USC Reference: USC131  
Council reference: MCU2026/0003  
SARA reference: 2603-51385 SRA

## **INFORMATION REQUEST RESPONSE 3-9 NORMAN DUNGAVELL DRIVE, QUEENTON**

**RESPONSE TO SARA ADVICE NOTICE – 3-9 NORMAN DUNGAVELL DRIVE,  
CHARTERS TOWERS QUEENSLAND  
SARA Reference: 2603-51385 SRA**

**SITE BASED STORMWATER MANAGEMENT PLAN**

**DRAWING NUMBER**  
**MOD25169QLD - SK03**

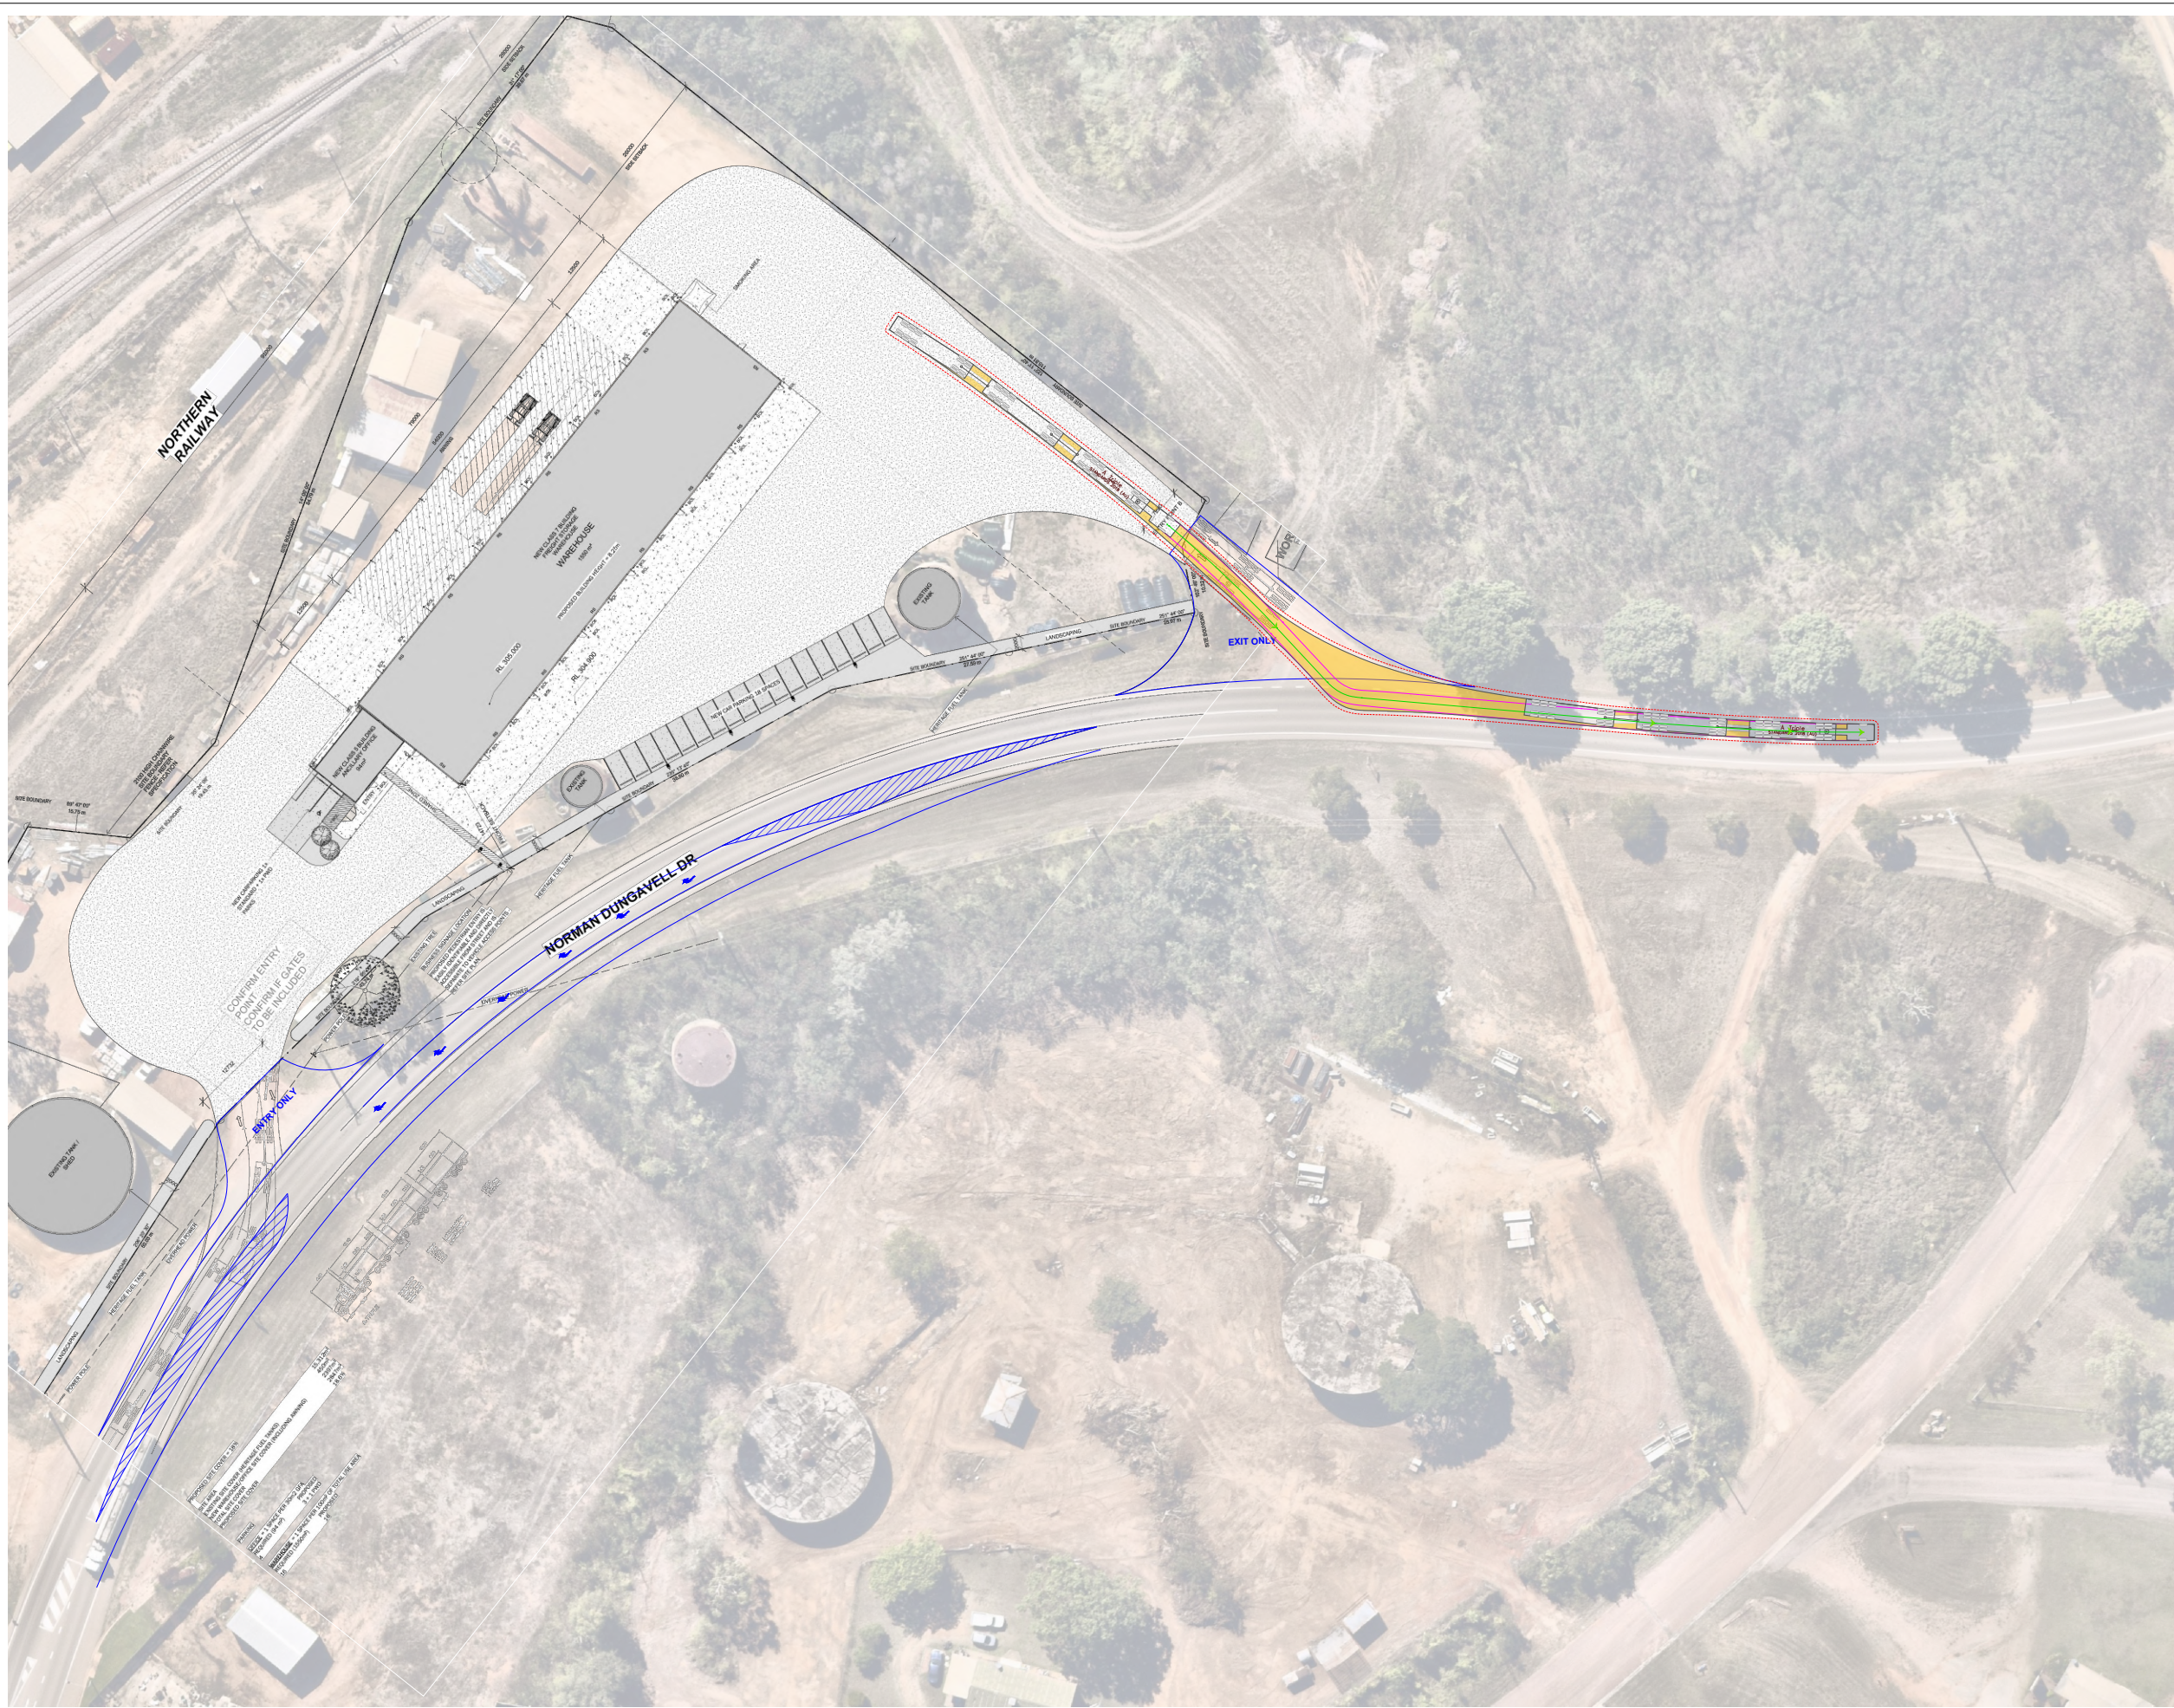
- *The conflict point for assessment of SISD should be based on the design vehicle swept paths, rather than an arbitrary point in front of a vehicle propped to exit the site. Consideration of the swept paths within the SISD assessment would shift the conflict point much further west than has been assessed, particularly for an A-triple turning right out of the site.*

- *Provision of a BAR would be reliant on acceptable SISD to the rear of a propped vehicle as required by Section 3.2.2 and Figure 3.3 of AGRD4A. As per drawing SK03, SISD for the BAR will be difficult as the SISD travels through third party land and also vegetation/fencing hence, the provision of a CHR(S) requires consideration.*

The revised SISD assessment, demonstrated on the revised Traffic Plans provided at **Appendix B**, demonstrates the minimum SISD of 135.8m is achieved for vehicles exiting the site. It is noted that the SISD assessment has been taken from the location in which an A-Triple will store when seeking to undertake a right-out movement.
